# Pool And Recreation Areas

Friday, December 4, 2015

Prepared For Fort Myers Beach

Identified 31 Issues

### **Basketball Hoop Repair**

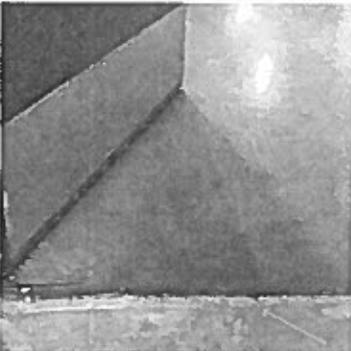
Recommend repair of basketball goal

### **Basketball Court**

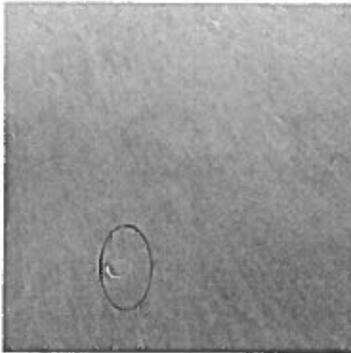
Recommend floor repairs. Overall the gym floor is still in decent shape for the age of the floor.

### **Broken Light In Gym ADA Bathroom**

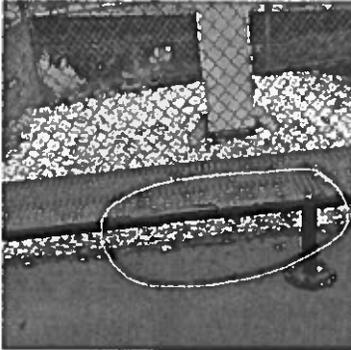
Recommend repair of lights in ADA bathroom as this is a safety and risk hazard. I talked to staff and they did admit that they knew the lights did not work.

### **Tennis Courts Broken Outlet**

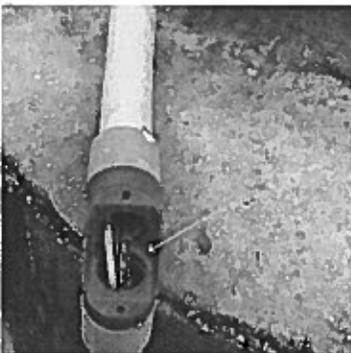
Recommend the replacement of electrical outlet. This is a safety and liability hazard.

### **Exposed Wires**

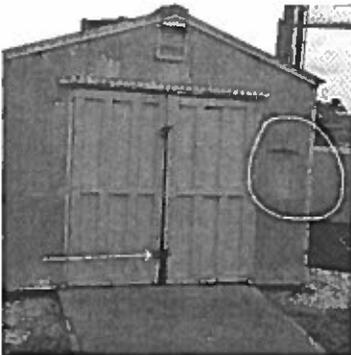
Recommend replacing cover for baseball score board for the field closes to tennis court. This is an electrical hazard.

### **Needs Sign For Gas Storage**

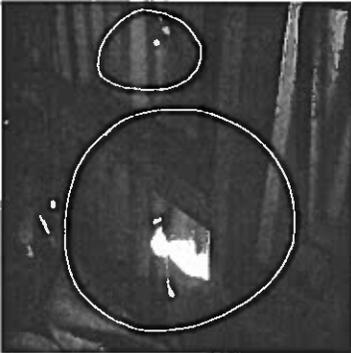
Recommend replacement of storage shed as it is at its useful life. There needs to be a sign for the storage of gasoline on the outside for fire department to have notice of gasoline.

### **Nails Coming Thru Fence**

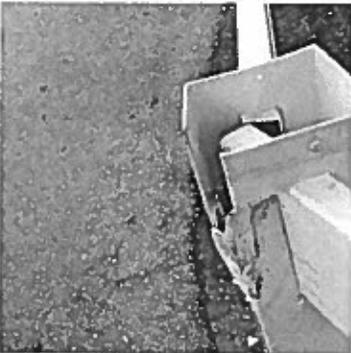
Recommend repair of electrical outlet that is attached to post that now is missing back piece. Now nails are exposed thru the fence and could cause injury.

### **Parking Lot Repair**

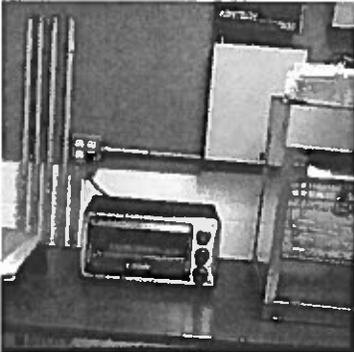
Recommend repair of pavement. Tripping hazard.

### **Electric Room And Cooking Food**

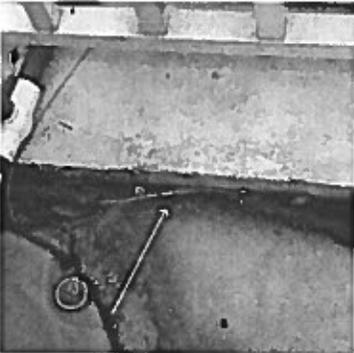
Recommend no cooking in electric room in pool area and removal of cooking equipment. This is a safety hazard.

### **Pool Slide Structure Failure**

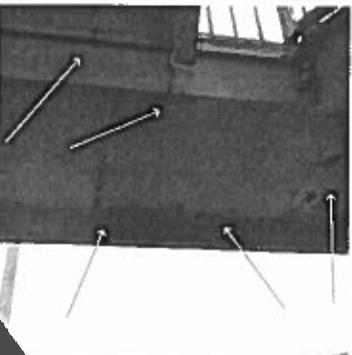
The safety railing has deteriorated and become detached from the structure of the water slide. Recommend the repair or replacement of railing. This is a major structure failure hazard.

See previous comments, structure failure.

### **Pool Slide Stairs**

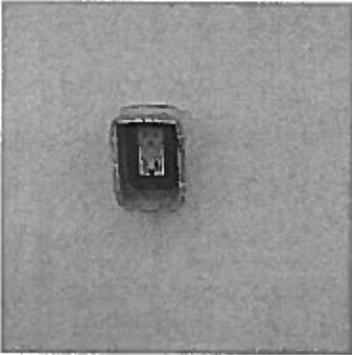
See previous comments, multiple repairs.
